**Addendum No. 1**

RE: Contract # C204684

**Haywood County (B-3186, B-5898)**

BRIDGES #155 AND 158 OVER RICHLAND CREEK ON US-23/74 AND  
BRIDGE #168 OVER US-19 AND US-23 ON US-23/74.

PMP 1

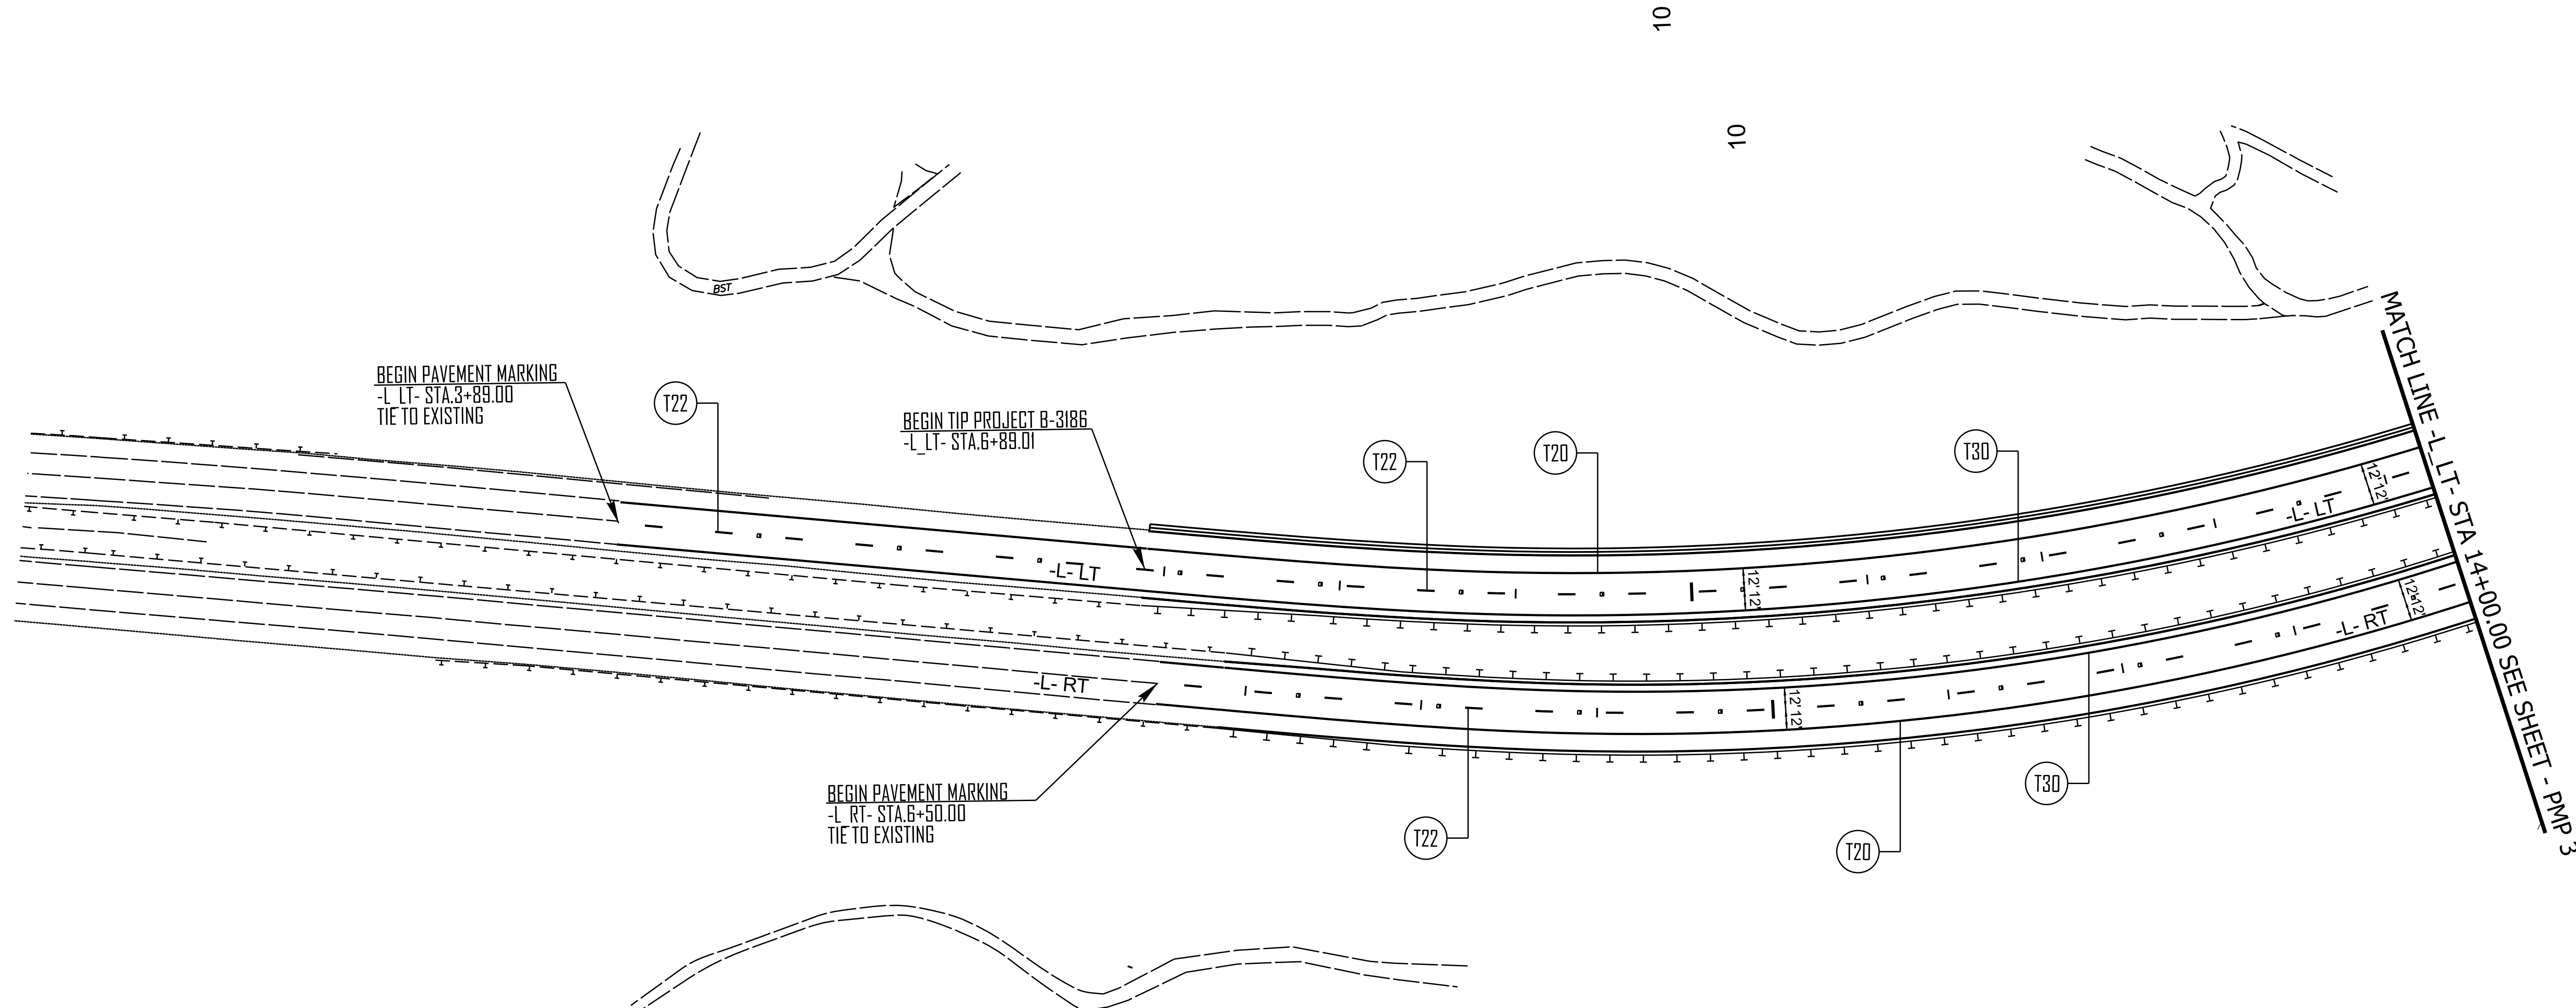
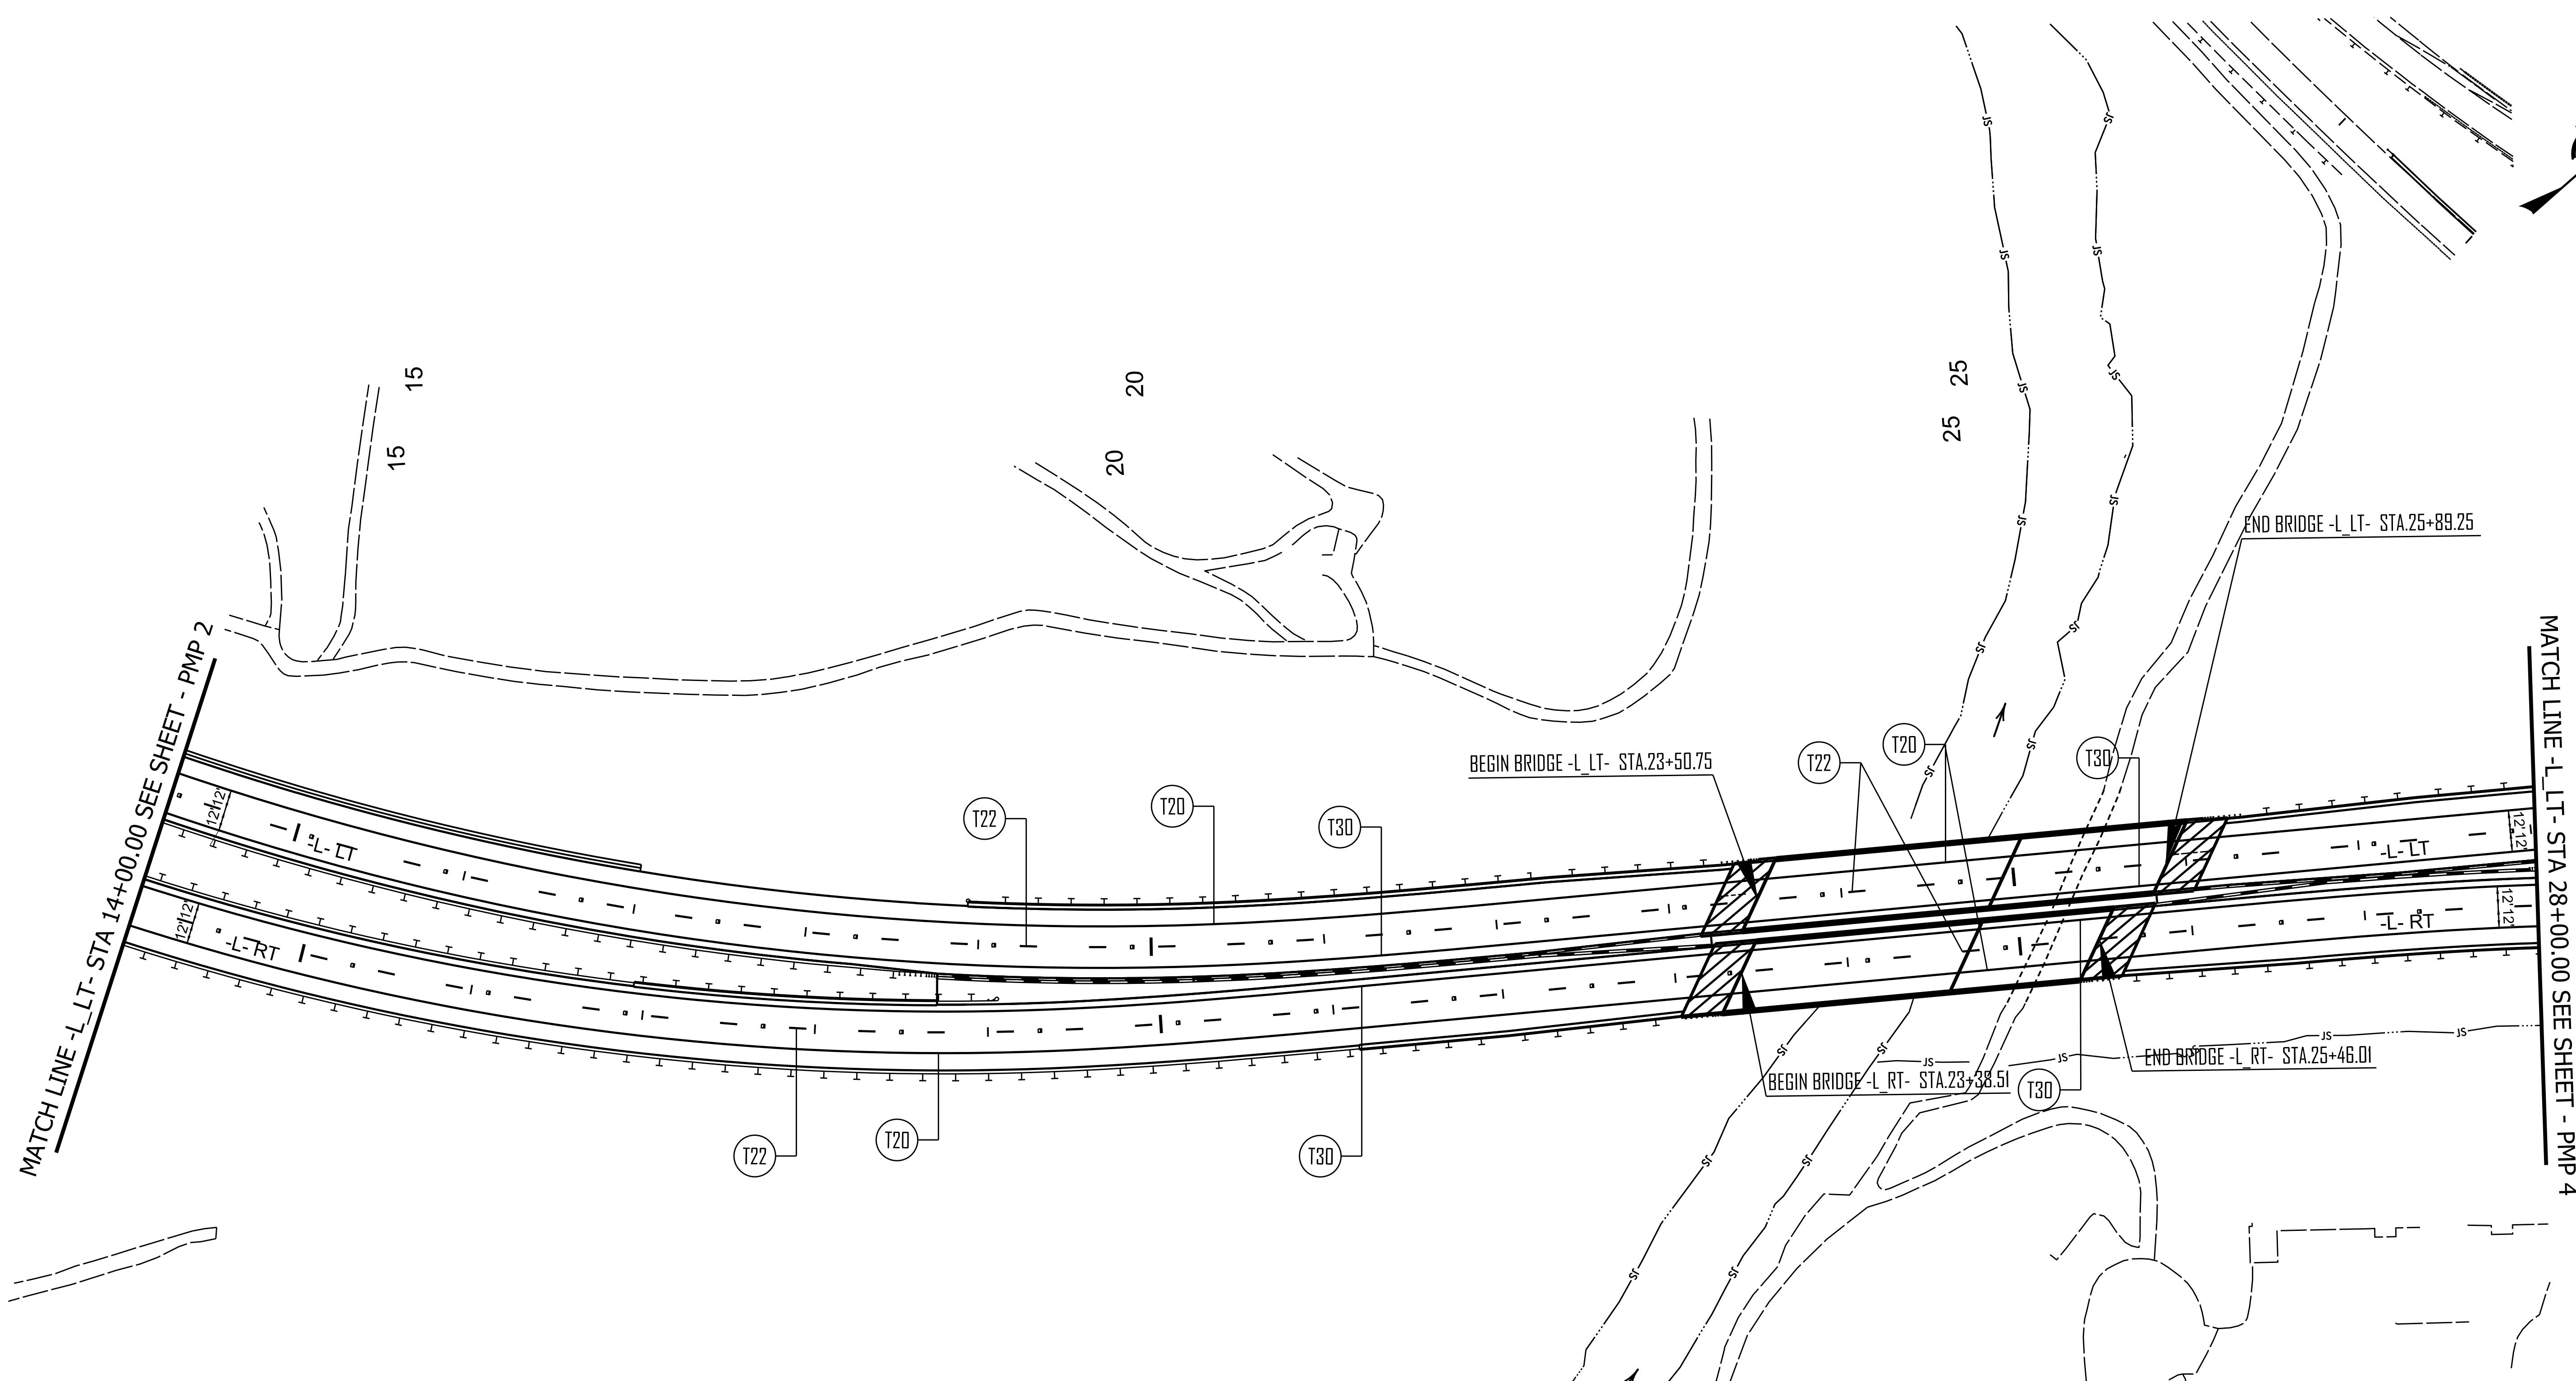
Sheet No.	Revision
PMP-1 thru PMP-5	Final Pavement Marking Schedule revised.
PMP-4 thru PMP-5	Merge arrows added, gore area striping revised.
